**Re: SSD 10367 - CGO Underground Development Project - Response to request for information**

**Table 1 Evolution comments on DPIE Water recommendations**

Evolution Mining  
Cowal Gold Operations  
DPIE submission  
Figure 1

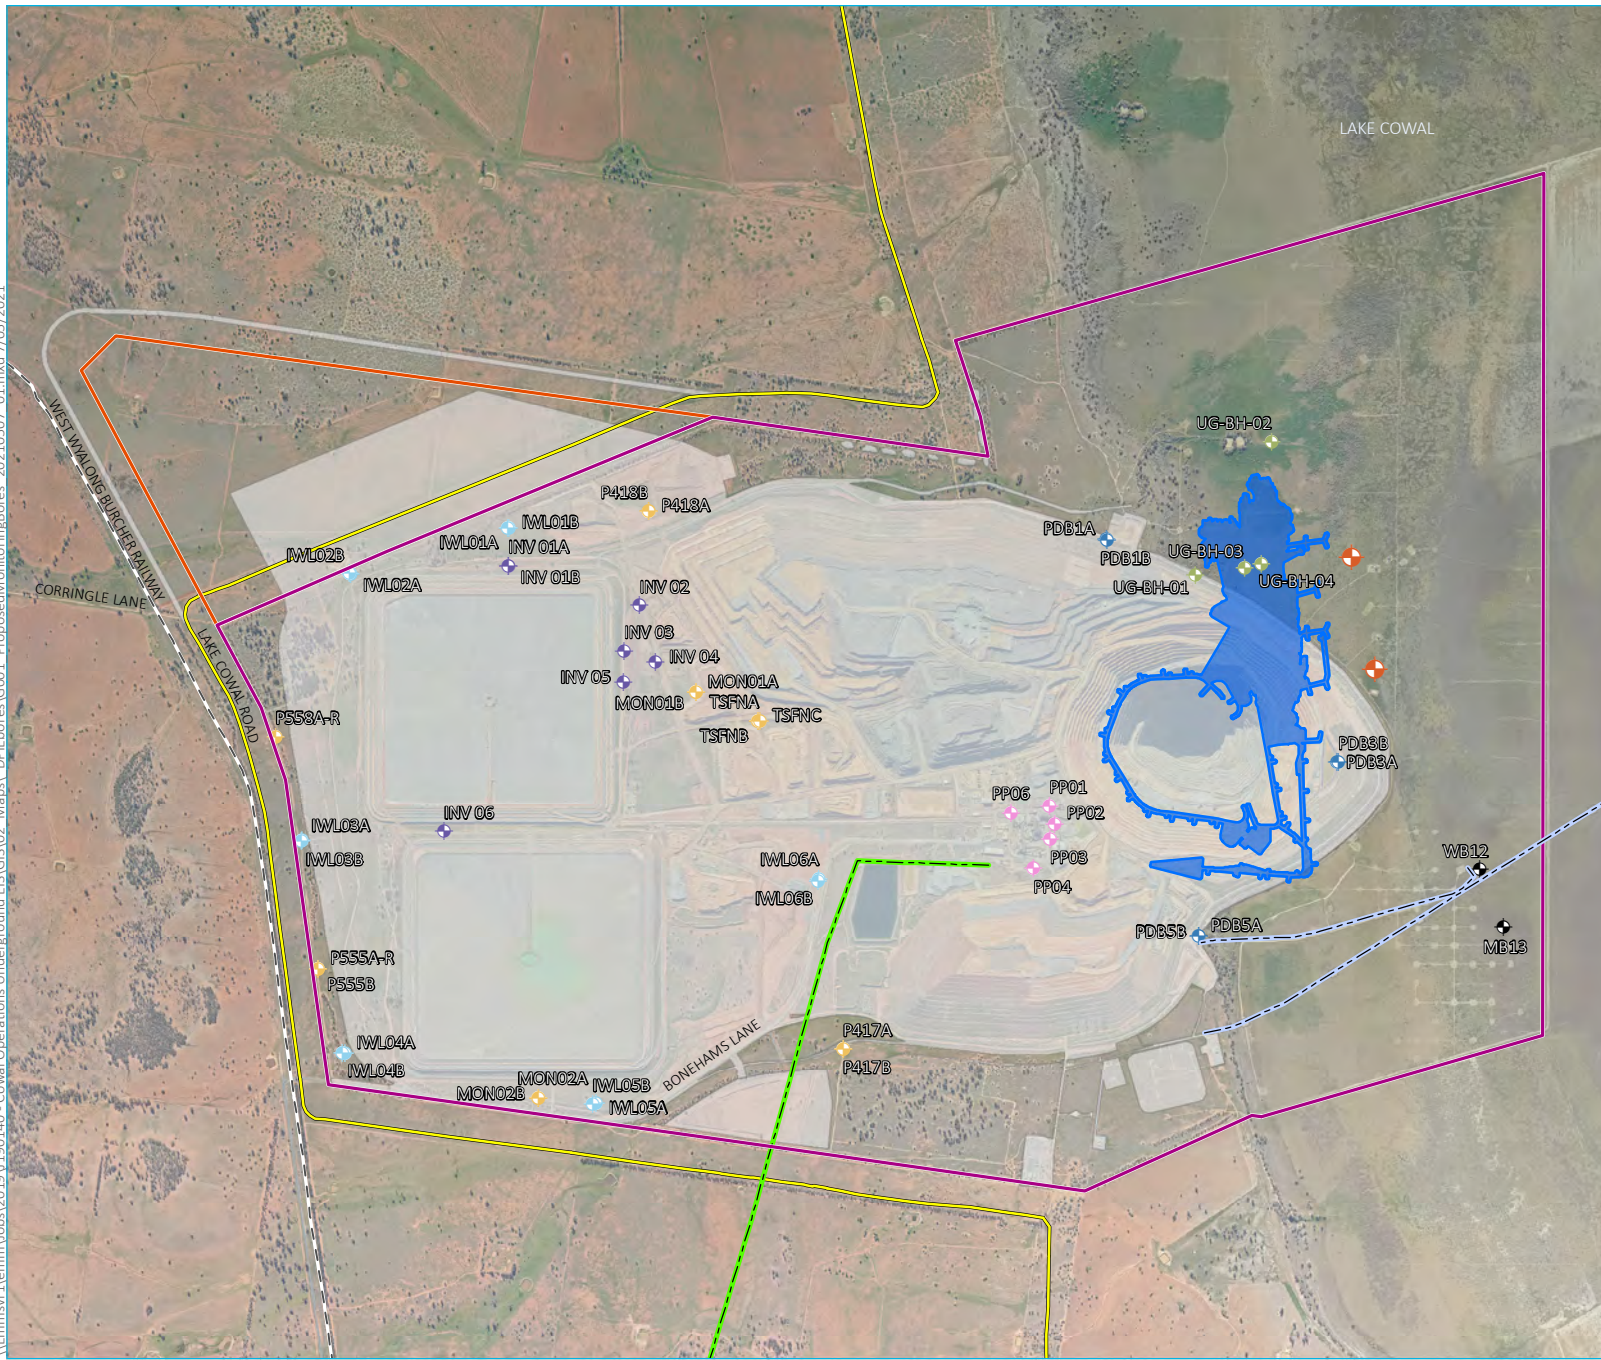
Recommendation	Evolution response
<p>1. Install a minimum of two nested monitoring bore sites, both with separate pipes which are screened in the alluvium (Transported Unit) and the underlying Lachlan Fold Belt sequence (saprolite/saprock). These are to be installed parallel to and adjacent to the proposed underground mine alignment within the mining lease covering Lake Cowal.</p>	<p>Evolution will commit to installing nested pair of piezometers to target the Transported and Saprolite/Saprock layers each in separately drilled locations. The piezometers will be installed prior to the development of the stopes, subject to being able to access the lake. A plan showing the indicative locations of the proposed new piezometers is attached (see Appendix 1).</p>
<p>2. Maintain and undertake extension to the groundwater monitoring program as outlined in this RtS for the duration of the current and future Cowal Gold Operations. Any extensions or changes to the groundwater monitoring network will need to be reflected in an update to the Water Management Plan.</p>	<p>Evolution will commit to maintaining and extending the groundwater monitoring program for the current and future operations of the mine and reflect the changes in the Water Management Plan. This will include gathering data from the additional nested piezometers.</p>

6. Update the WMP to include the two additional nested monitoring sites.	The updated Water Management Plan will include the additional nested piezometers.
